PROPOSED TE PŪTAHI LADIES MILE PLAN VARIATION

RESPONSE OF JOHN GARDINER ON BEHALF OF THE QUEENSTOWN LAKES DISTRICT COUNCIL

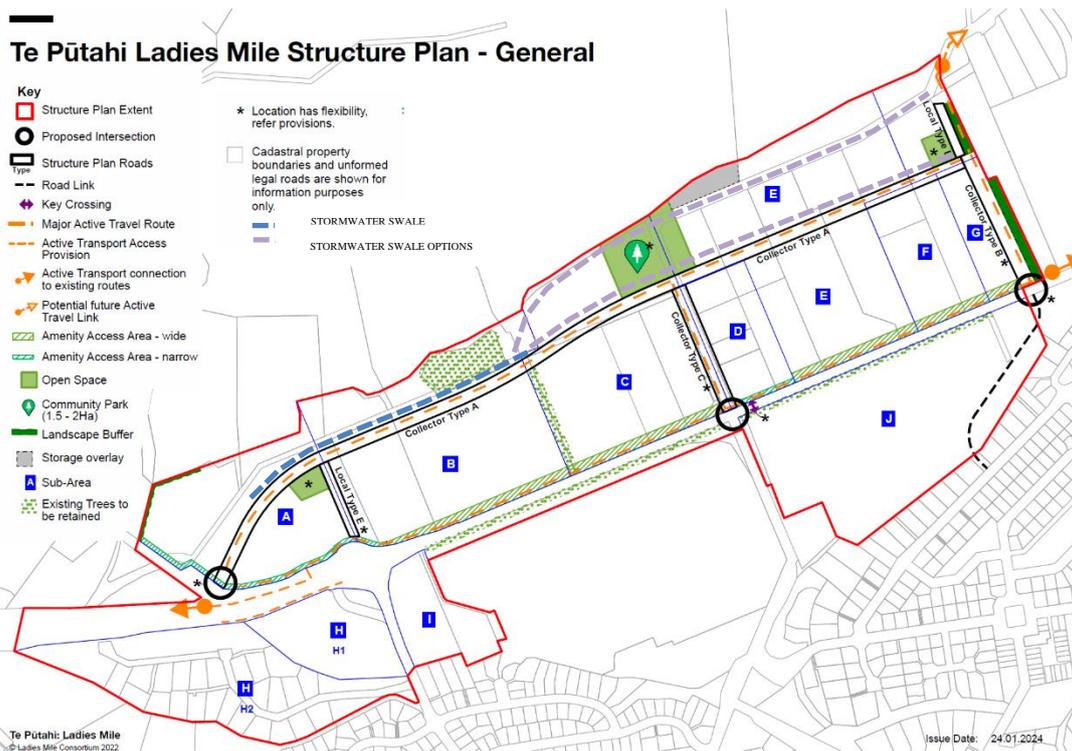
- 3 At the Hearing, the Hearing Panel asked the Council to consider whether the proposed stormwater swale should be shown on the Structure Plan.
- 4 I am of the opinion that a stormwater swale alongside Collector Road Type A / toe of Slope Hill should be shown on the Structure Plan as indicated in the diagram below.

- 5 For the western section, the toe of the slope and the Collector Road Type A are close to each other compared to eastern section. Accordingly in my opinion the swale should be located along Collector Road Type A. When you get further east, the collector road and the toe of the slope are up to 150m apart. Accordingly, there will be more flexibility as to where the swale is located (i.e. right on the toe of the slope, or along Collector Road Type A) (hence why this is shown as noted “options”). Whilst there is more flexibility in the eastern part of the TPLM Variation area, I consider the provisions will achieve the necessary integration between the different landowners.
